Cleveland National Forest Power Line Replacement Projects

To: Lisa Orsaba, California Public Utilities Commission (CPUC); Allison Rice, Dudek
From: Kirstie Reynolds, San Diego Gas & Electric Company (SDG&E)
Date: May 7, 2020 (Revised May 29, 2020)
Re: Cleveland National Forest Power Line Replacement Projects, Phase II of Circuit 440
Minor Project Refinement Memo

ATTACHMENT C: PHASE II OF C440 COMPARE MAP

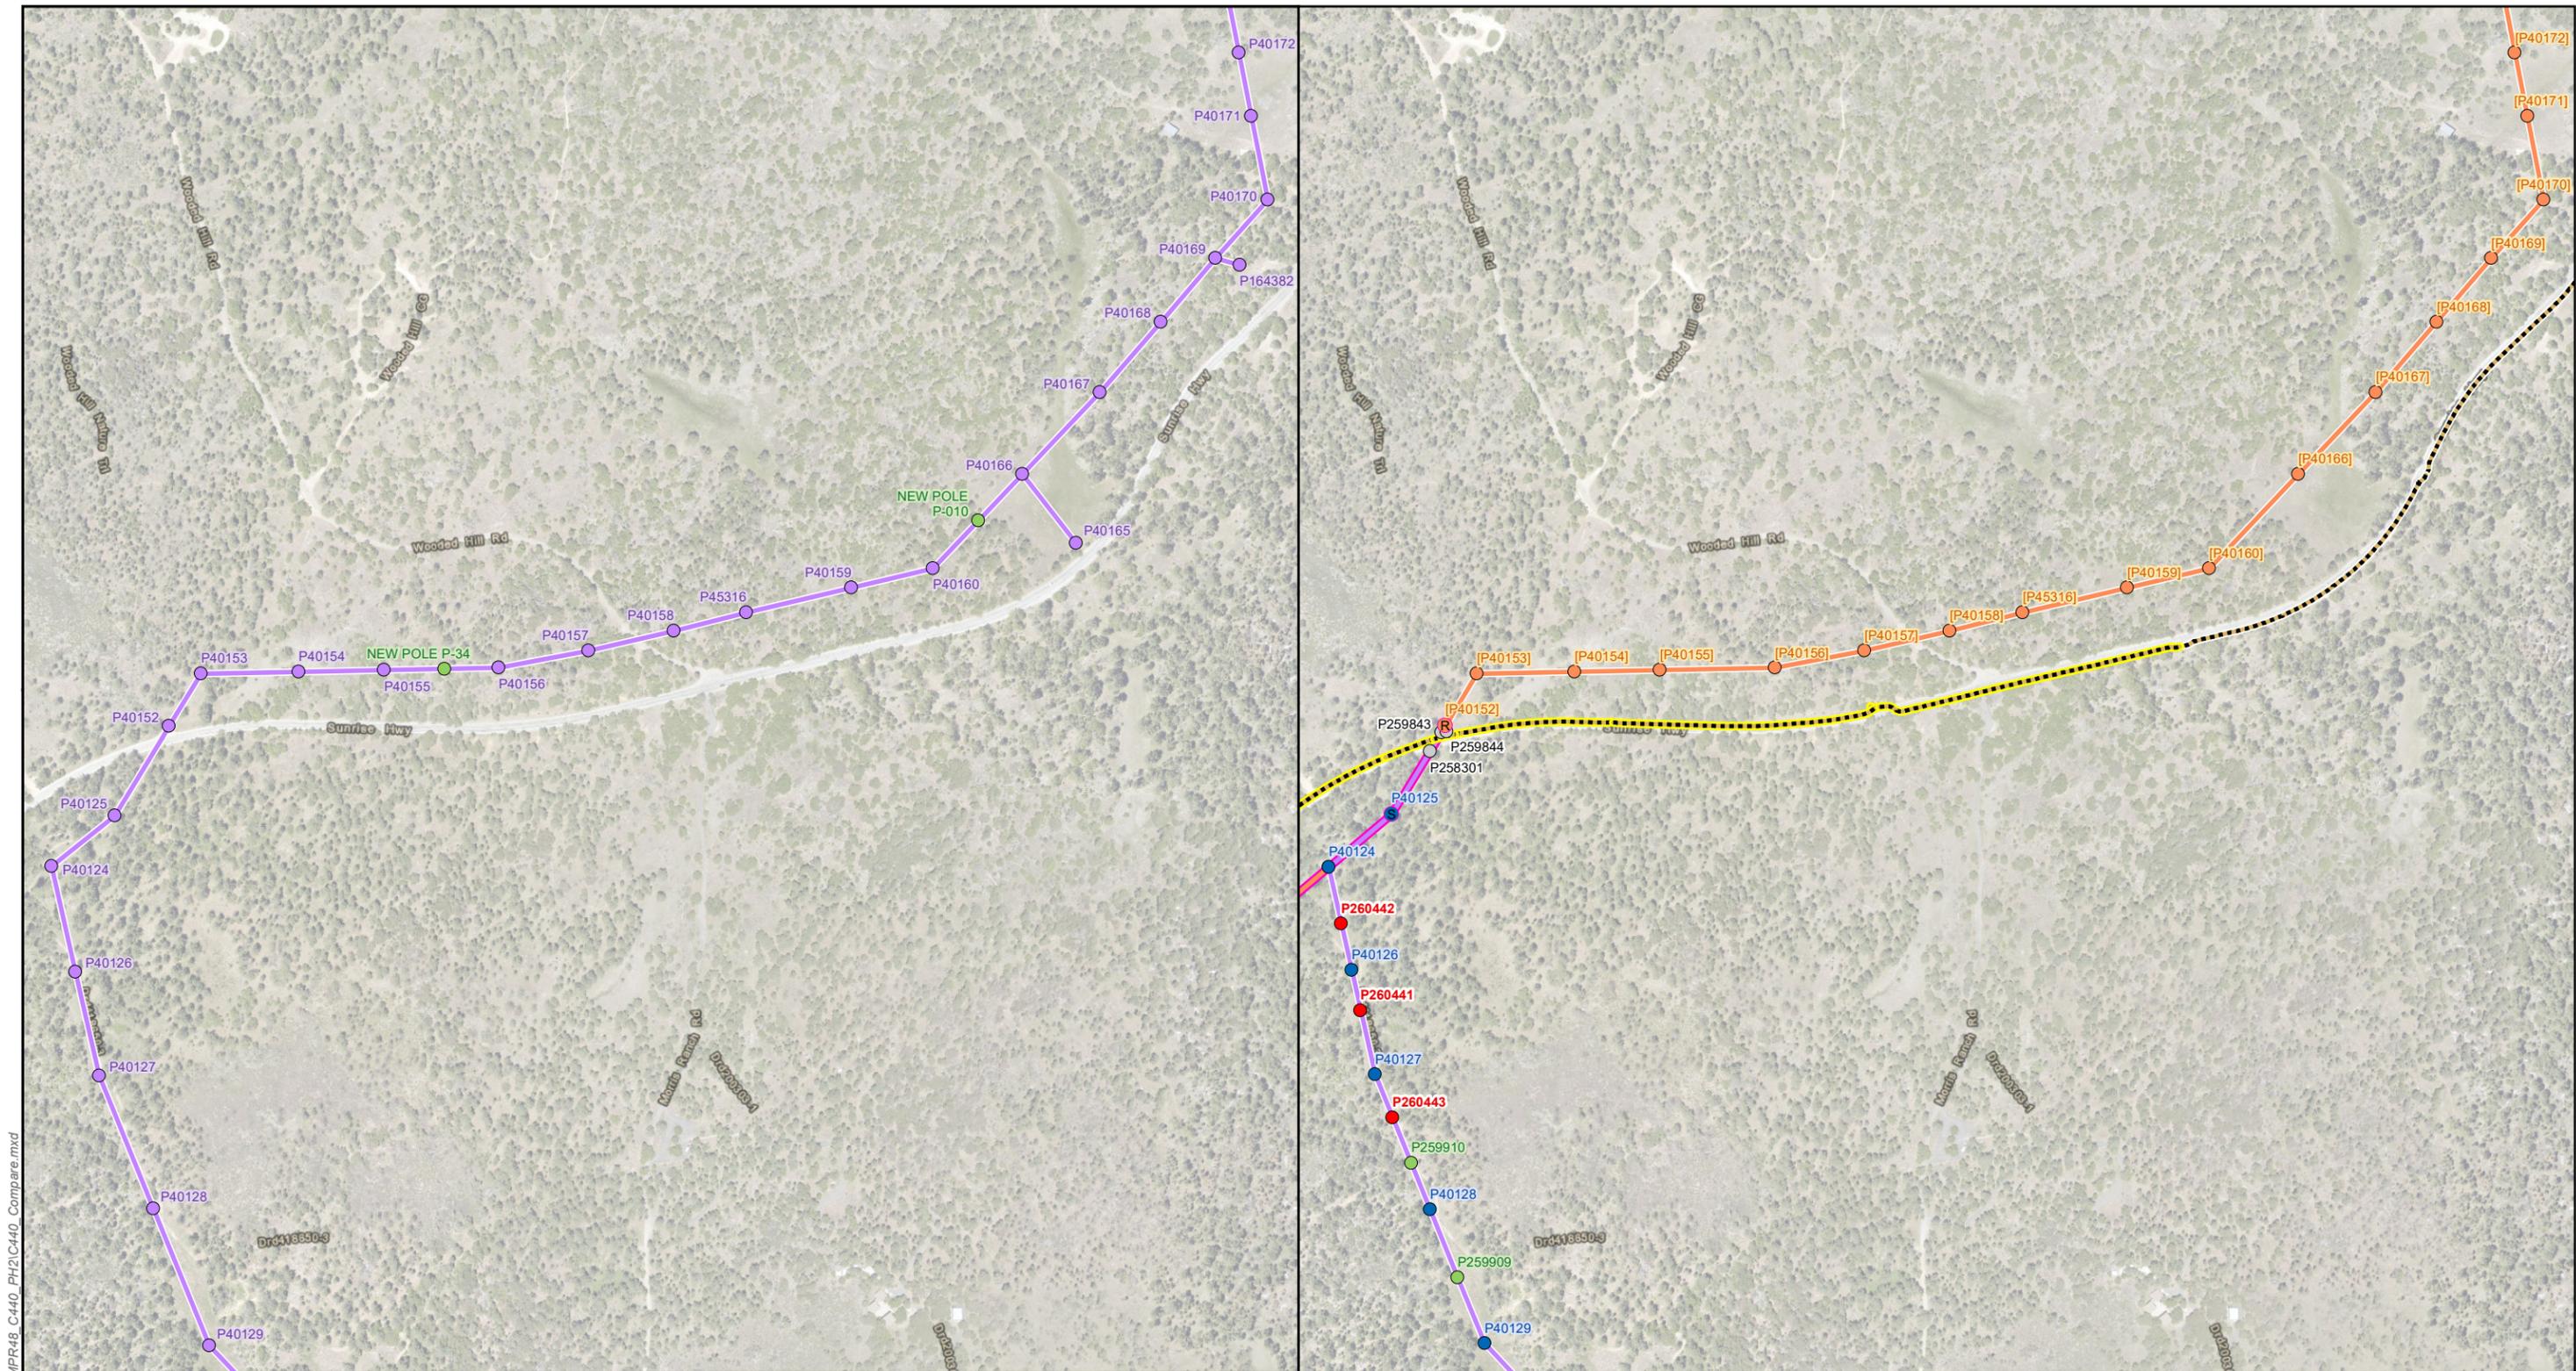
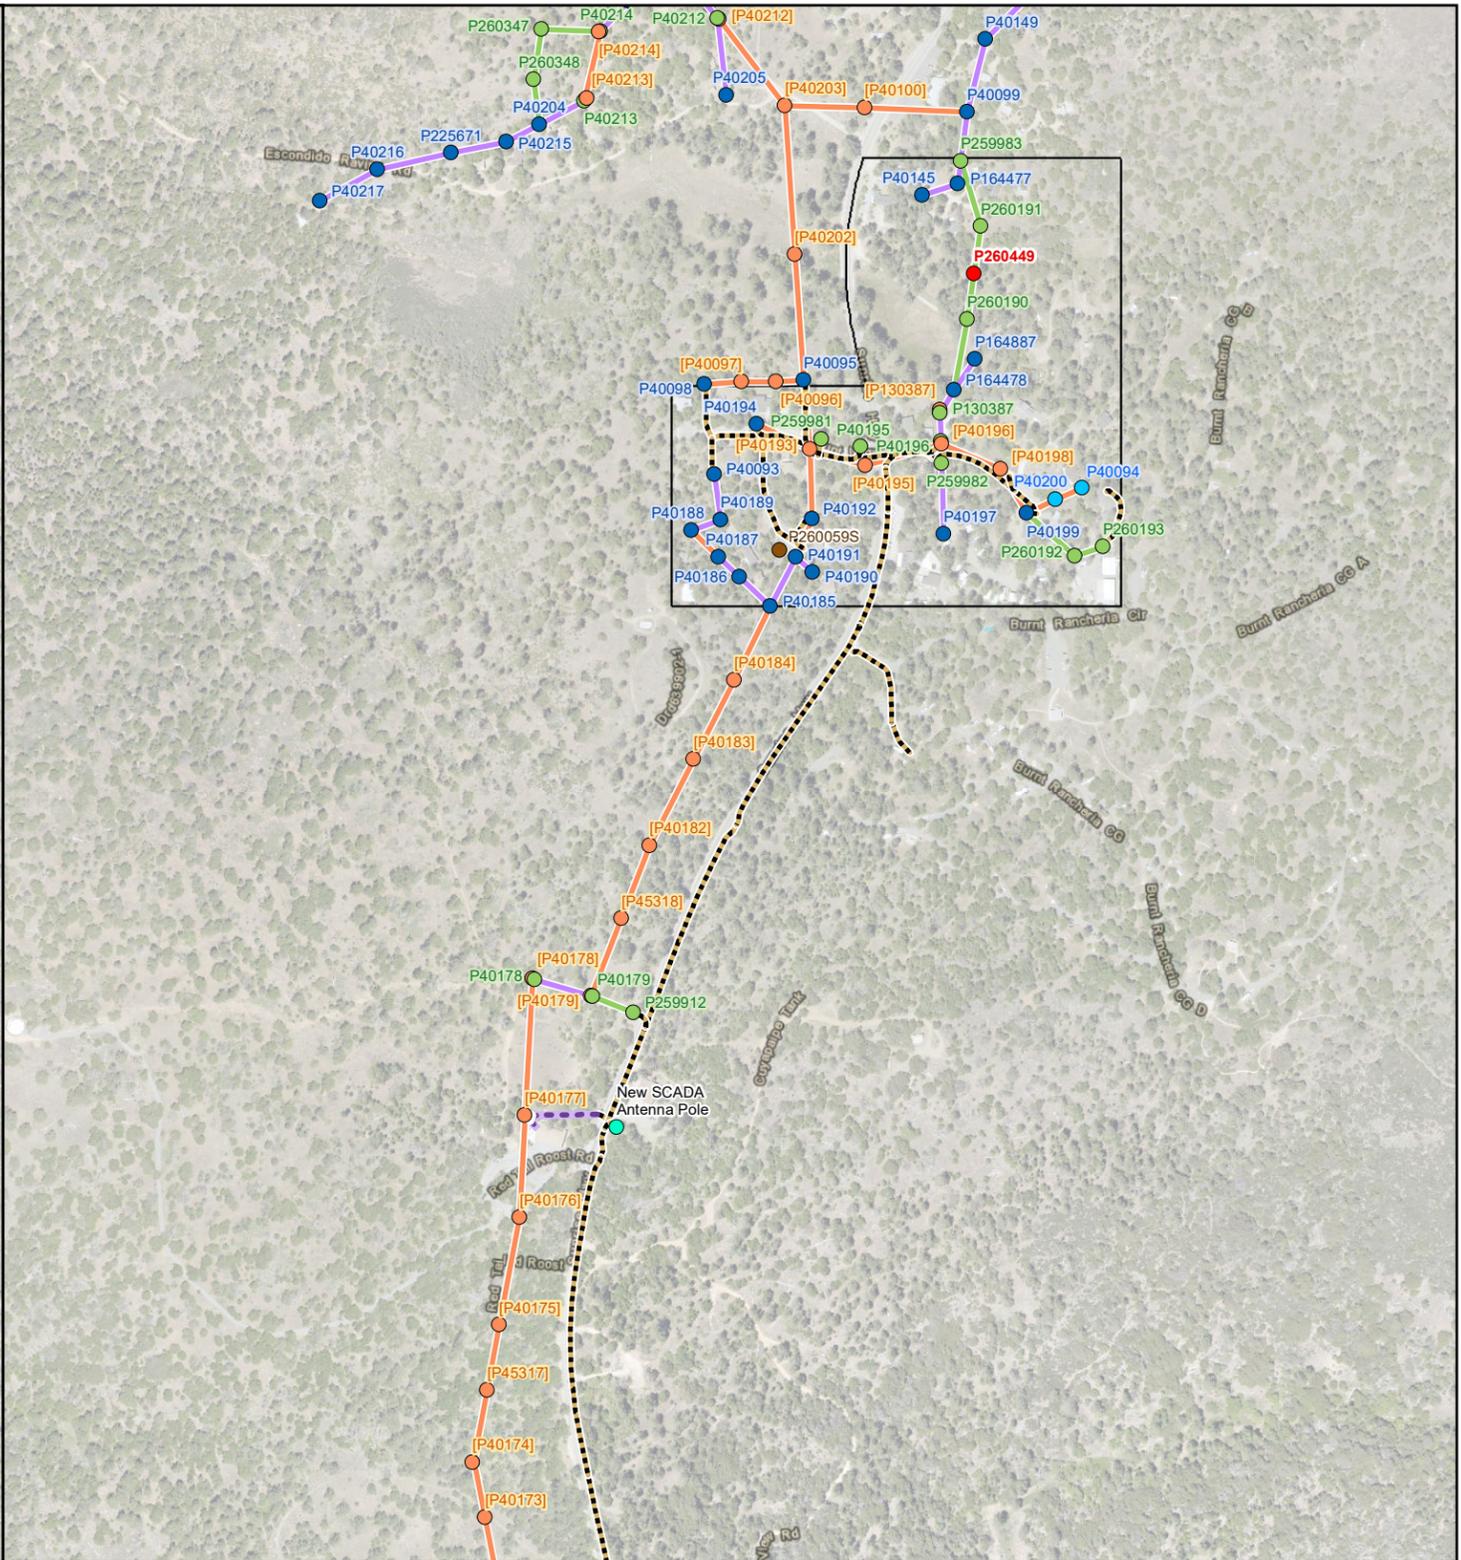
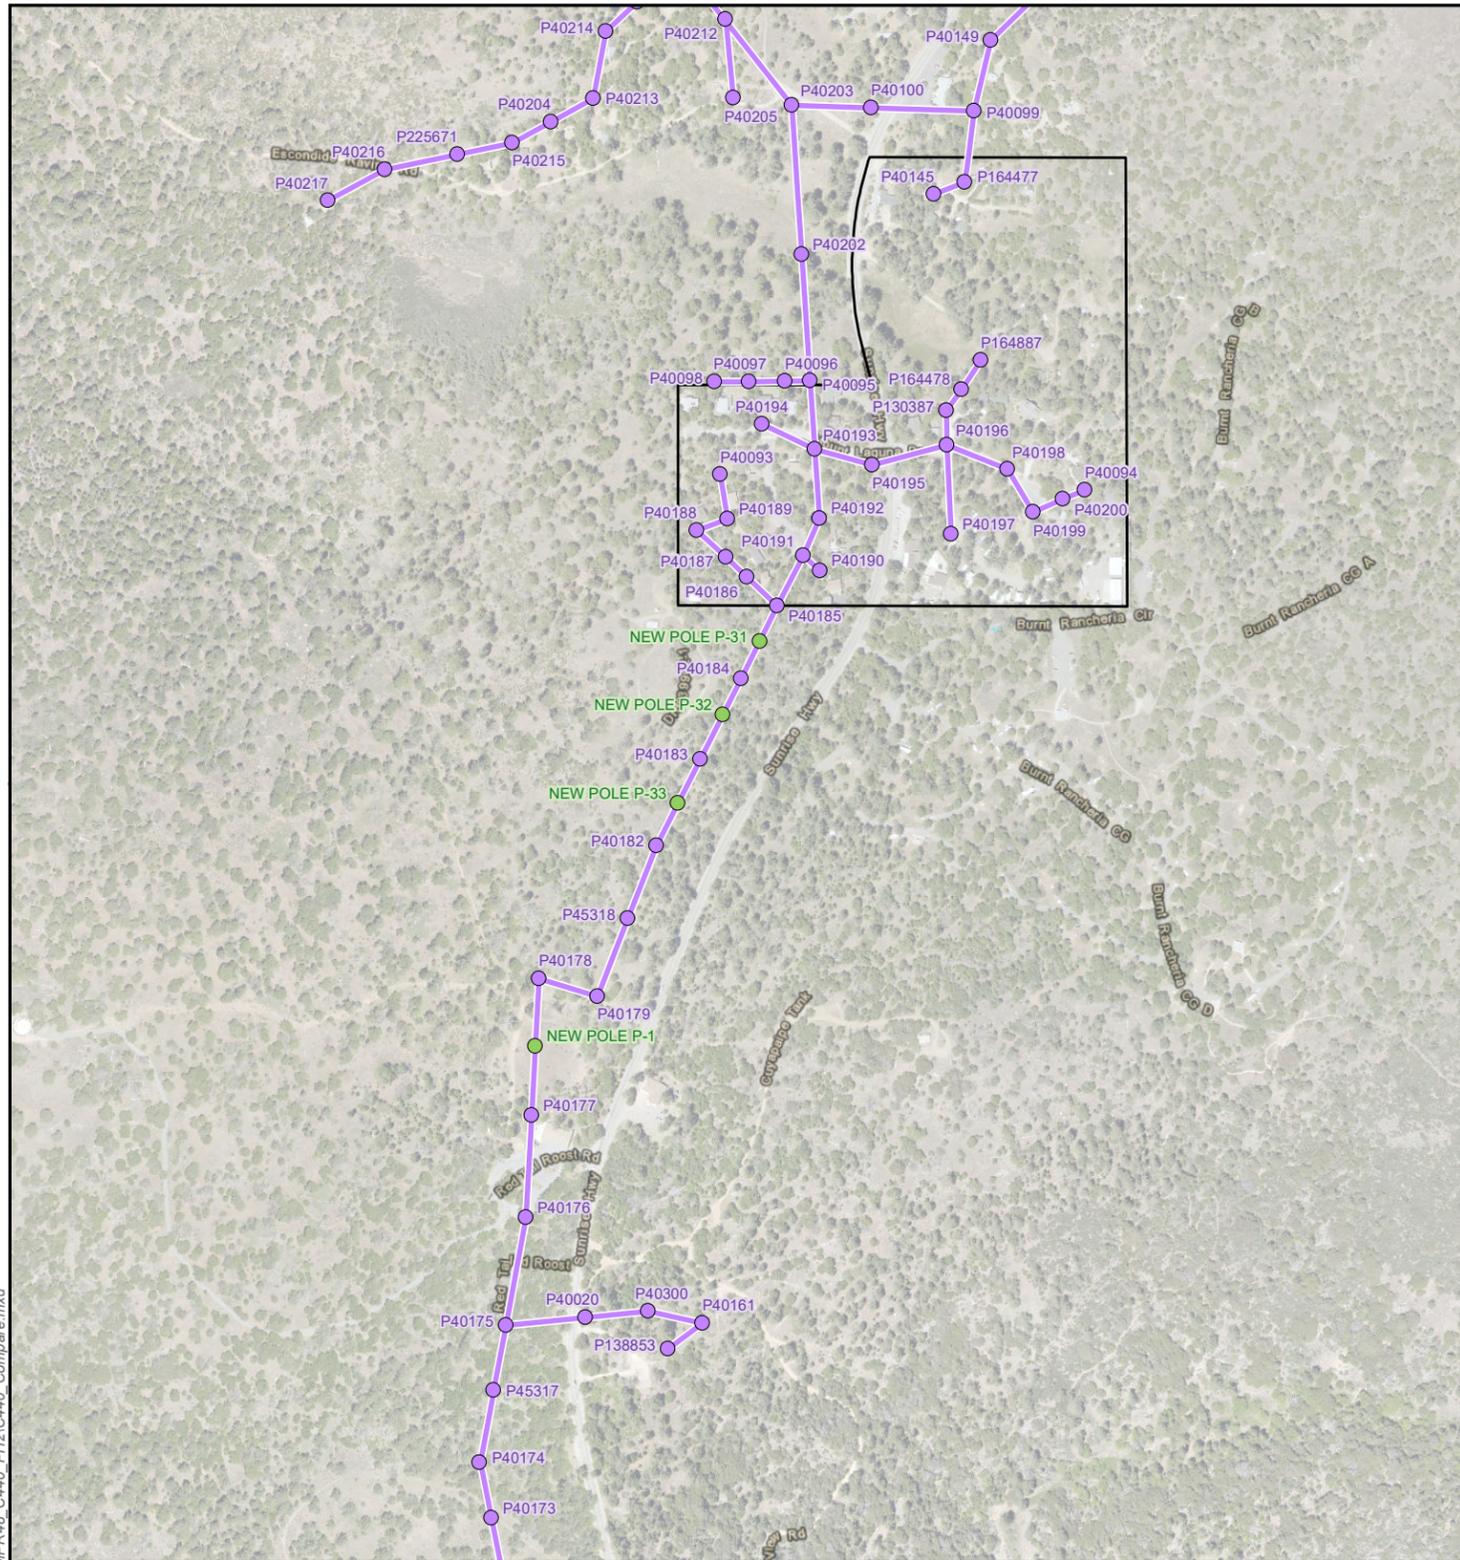
- Undergrounding along Sunrise Highway was stopped north of Mount Laguna Drive due to an ethnographic village site that was identified by the USFS. To reduce impacts to this significant cultural resource site, a portion of the existing overhead line west of Sunrise Highway will be removed and rerouted on the east side of Sunrise Highway as new overhead.

- Due to concerns expressed by the USFS regarding subsurface resources (i.e., hydrology) and the potential to create a dam effect that prevents water flow in the area, the final design includes the overhead rebuild, rather than undergrounding, of the existing overhead parallel to Los Huecos Road.

- Near Little Laguna Lake, to prevent impacts to sensitive biological and cultural resources, the final design includes overhead rebuild rather than undergrounding.

- Due to concerns expressed by the USFS regarding biological resources, vernal pools, subsurface resources (i.e., hydrology), and the potential to create a dam effect that prevents water flow in the area, as well as potential impacts to sensitive cultural resources, the final design includes overhead rebuild instead of undergrounding within the existing road near the Laguna Campground.

A map comparing the Proposed Project to the final design for Phase II of C440 (i.e., NTP request #27) is attached at Attachment C: Phase II of C440 Compare Map. All underground components that were carried forward from the Federal Preferred Alternative are included under a separate header (Federal Preferred Alternative) in the legend for the final design. Table 1: Phase II of C440 Undergrounding Comparison displays the miles of undergrounding that was anticipated for the Proposed Project and Federal Preferred Alternative, and what is included in the final design.
